CONTRACT CHANGE ORDER NO. _____
 SHEET _____ OF _____

**DETAILS
SAS SUPERSTRUCTURE GIRDER WESTBOUND
TYPICAL LIGHTING INSTALLATION**
SCALE AS NOTED

CU 04251 EA 0120F1

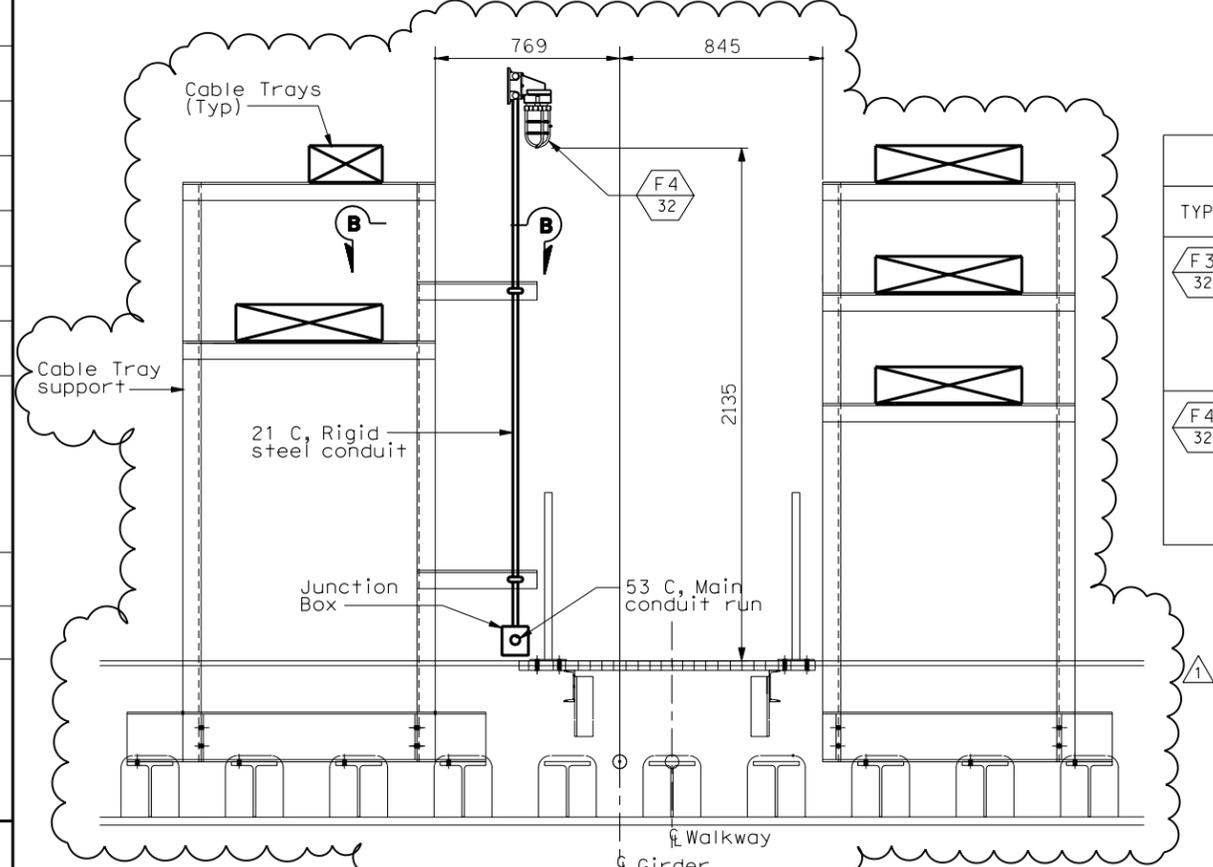
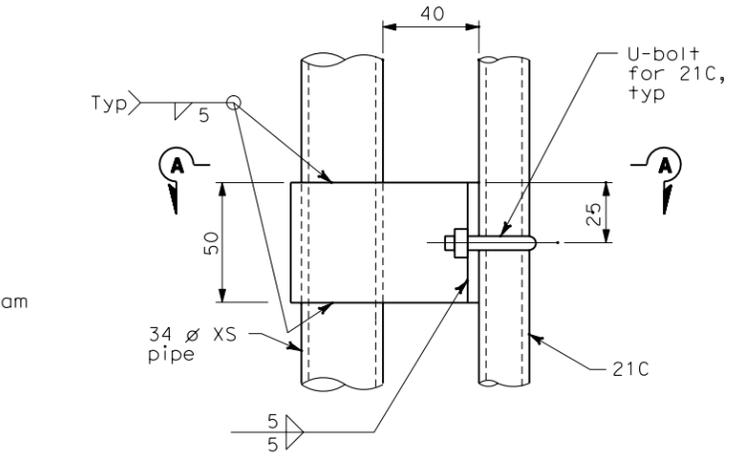
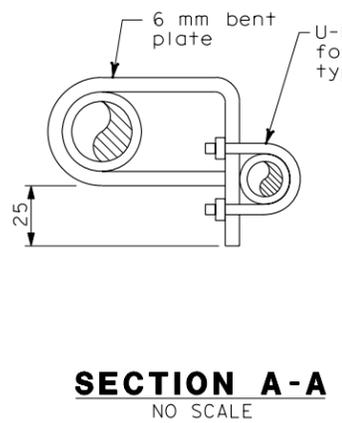
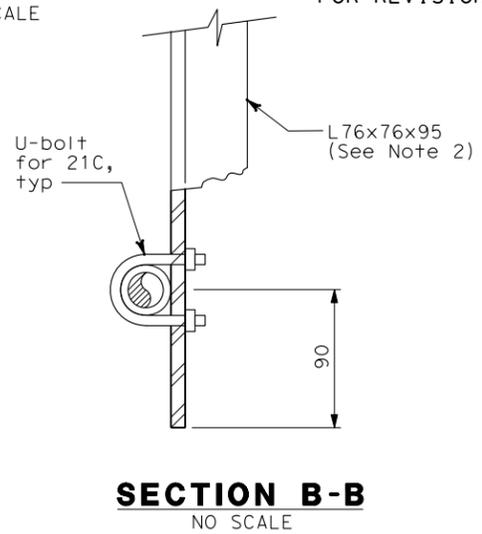
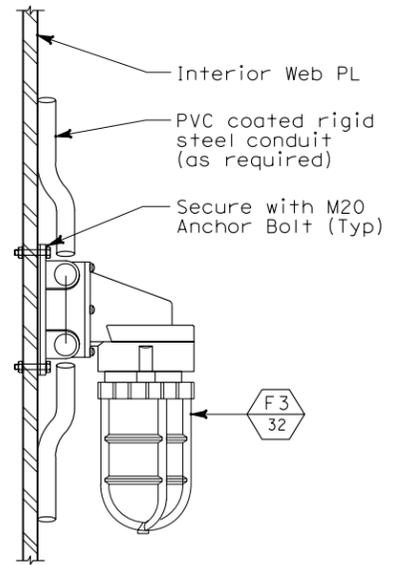
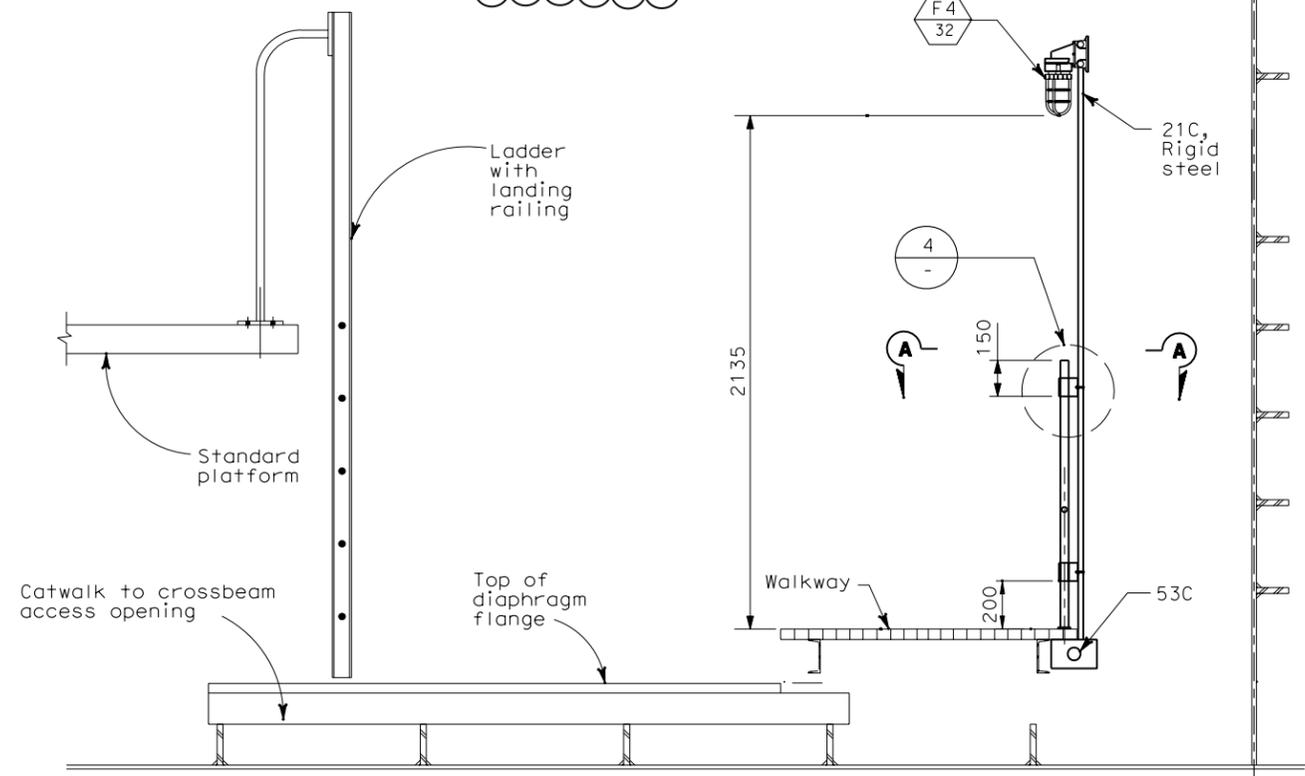
| REQUEST FOR INFORMATION NOT ADDRESSED IN THIS CCO REMAIN IN FORCE | | | |
|---|----------|--------------------|------------|
| △ | 02/25/08 | CABLE TRAY CHANGES | TW |
